SUBSURFACE INVESTIGATION REPORT

265 CENTRUM BOULEVARD, OTTAWA, ON, K2S 1V4

Report number: 54-BOI-R2¹
August 29, 2023

This section provides information to amend this report in response to requests made by the City of Ottawa (C of O). The current request in question is: “MEMO / NOTE DE SERVICE; File No. D02-02-23-0021 & D07-12-23-0033” dated June 13, 2023 and it is in the form of the following numbered list:

Figure 2: Test hole Locations Plan

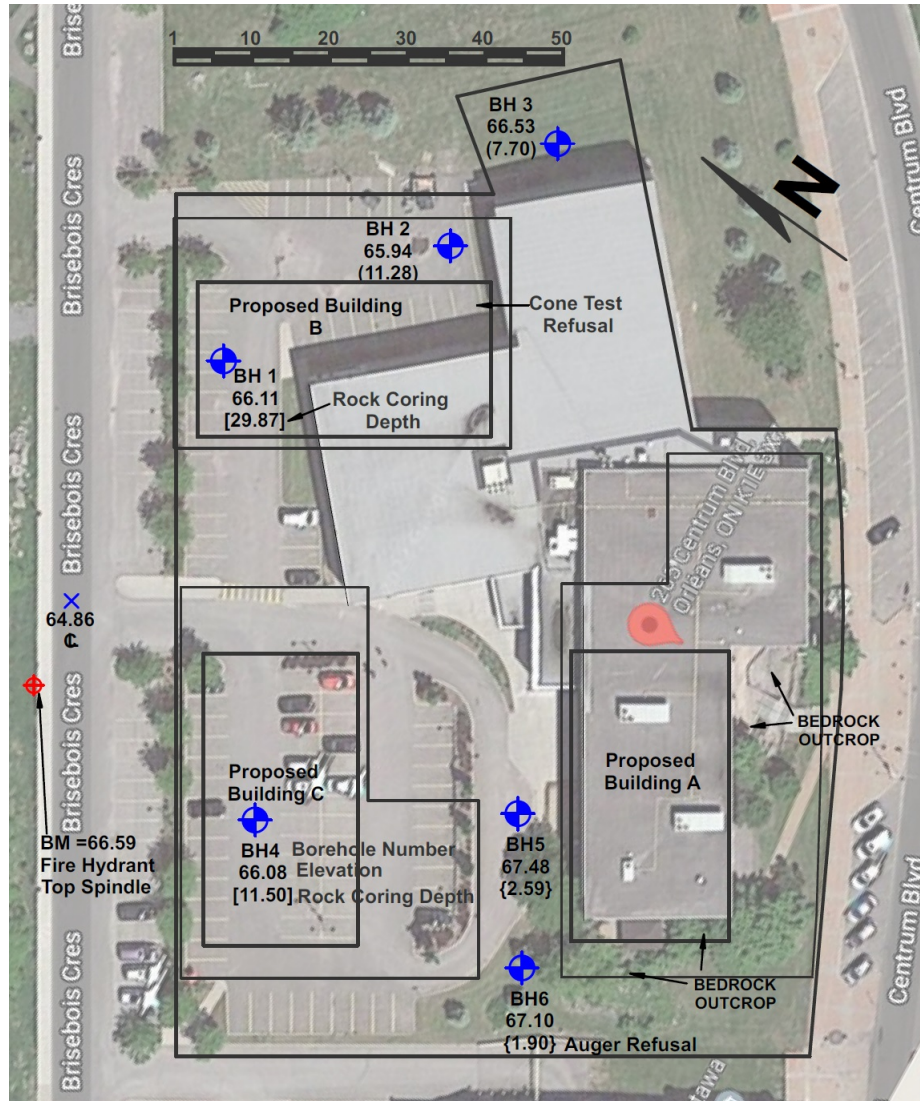
D1. Please clearly specify the spacing between boreholes. Include discussion in the report and refer to Table 1 in the City of Ottawa Geotechnical Guidelines for the maximum allowable spacing between boreholes and test pits. Note that the Geotechnical Guidelines must be upheld and further boreholes would be required should required spacing not be met.

Figure 2 in page 23 reproduces fig. 1 in page 9 with an added scale bar. It can be seen that the spacing meets the guideline of up to 50 m spacing between holes.

As the guideline must be “upheld” there is no possible outcome by discussing as it is all that matters.
